**RE: "PROSPECT LAKE CLEAN WATER CENTER" PLAT – CASE NO. UDP-EV24004
VACATION OF INGRESS/EGRESS AND WELL AND UTILITY EASEMENT
LOCATED ON PLAT BOOK 96, PAGE 35**

DRC Comment Report: ENGINEERING

DRC Comment Report: Stormwater Operations

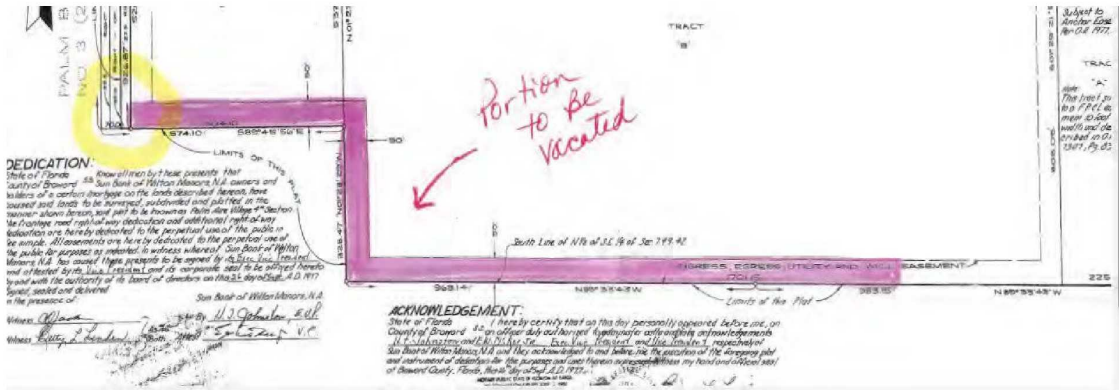
1. Stormwater Operations does not object to the developers ask to vacate the easement at this location if there is not conflict with the existing offset of the City's outgoing 36' (RCP) stormwater gravity main conveying stormwater from the north as depicted in the stormwater utility atlas image below (STGM11856). The stormwater atlas indicates that this 36 "gravity main runs south and connects and turns to the west at the identified nexus on its conveyance path to the point of discharge into Prospect Lake (STOF3801).

RESPONSE: The City's Public Works Department and Stormwater Operations determined that an easement 20'x50' would need to be dedicated to cover the existing 36' stormwater pipe that crosses the easement.
